Town of Kittery Planning Board Meeting July 27, 2023

ITEM 2 – 21 Badgers Island West– Shoreland Development Plan Review

APPLICATION & PLAN REVIEW

C-1.0

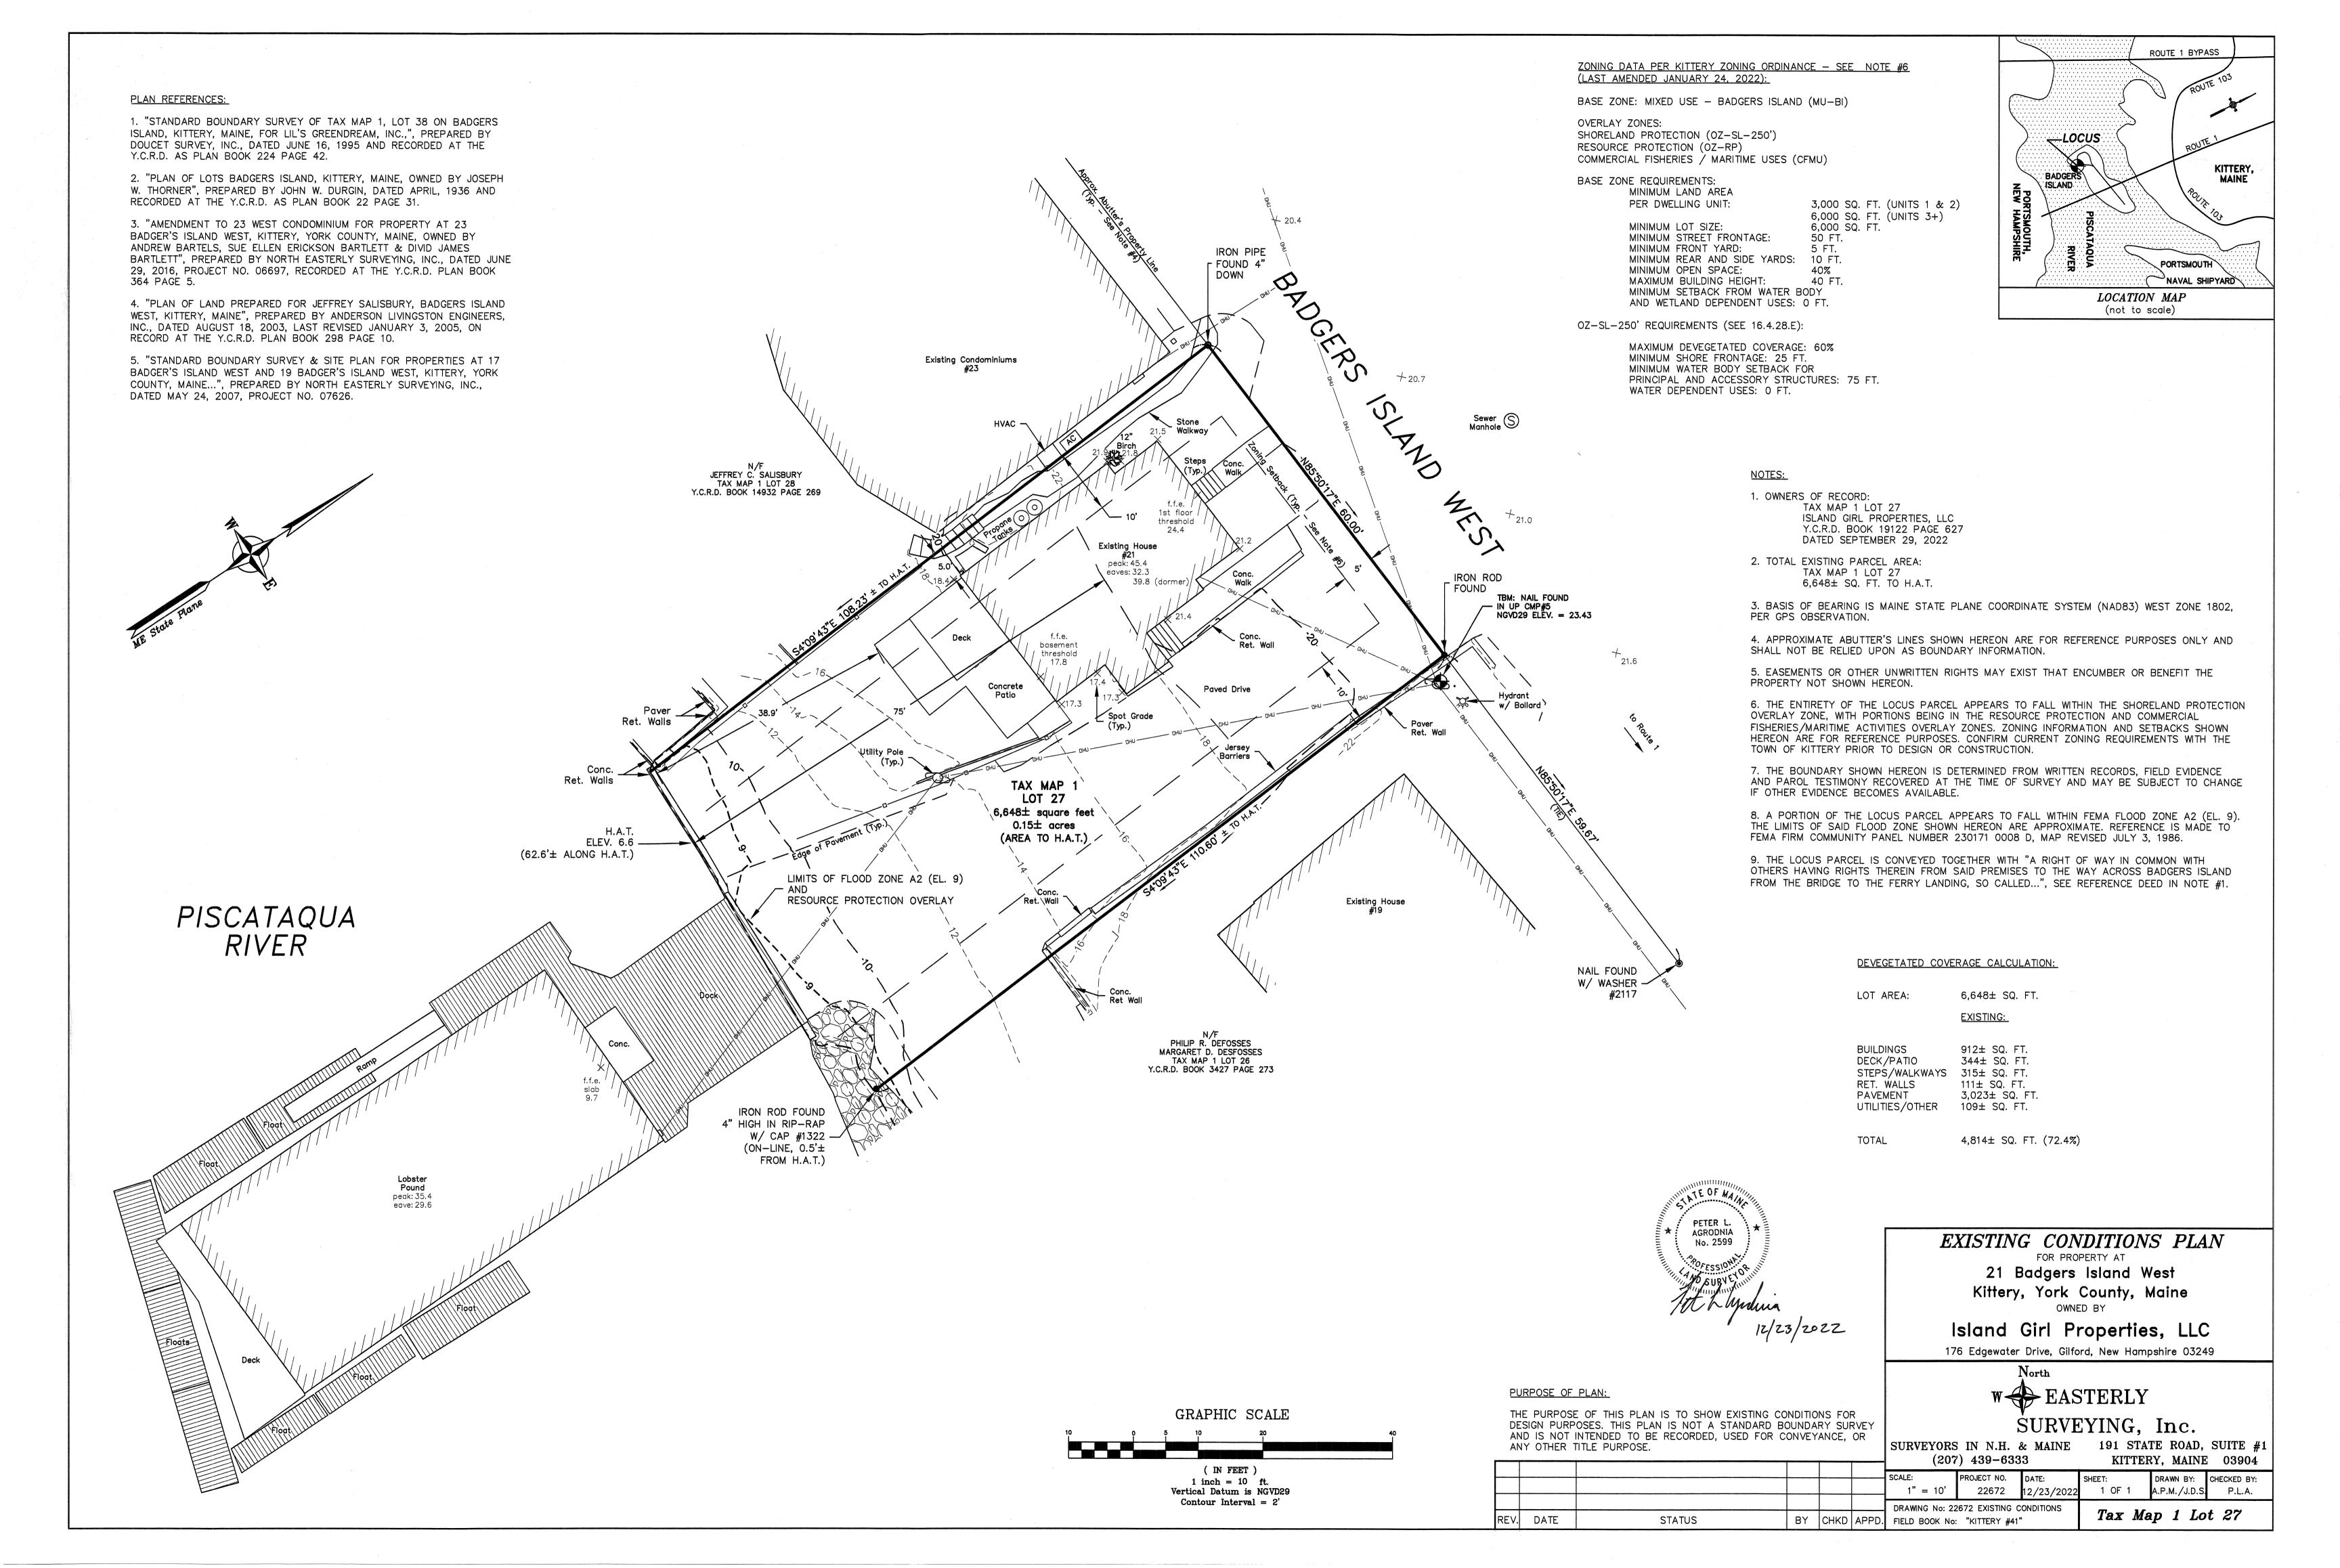
- 3. **§16.4.28.E.(2).(a).** allows 60% of total lot area in the Mixed-Use Badgers Island zone's shoreland overlay to be comprised of non-vegetated surfaces or structures. With a lot size of 6,648 sq ft, current devegetation sits at 4,814 sq ft, or 72.4%. The proposed development would reduce non-conformity by lowering the total devegetated area to 4,668 sq ft, or 70.2%.

- a. The notes on the site plan's devegtetation calculation only add up to 4,646 sq ft, do to an accidental omission of a granite stairway totalling 22 sq ft. The applicant confirmed 4,668 sq ft. is the correct number.

SILT AND ORANGE CONSTRUCTION FENCE LAYOUT DETAIL

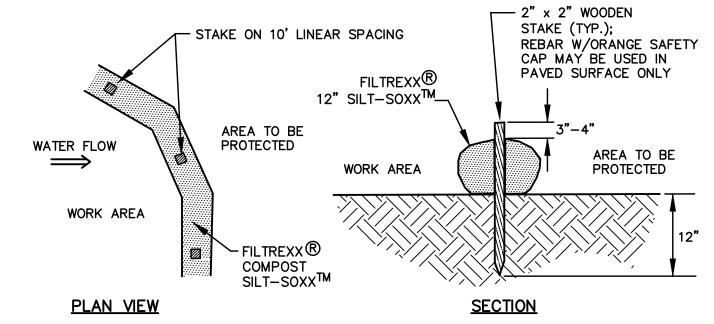
- 4. Erosion control measures shall comply with state DEP and local ordinances. The applicant provided a detailed layout of the silt barrier and orange construction fence that will be placed before construction and maintained throughout the development to protect the resource from erosion or sediment runoff. Disturbed areas will be stabilized with loam and seed plantings before removal of temporary erosion control barriers.
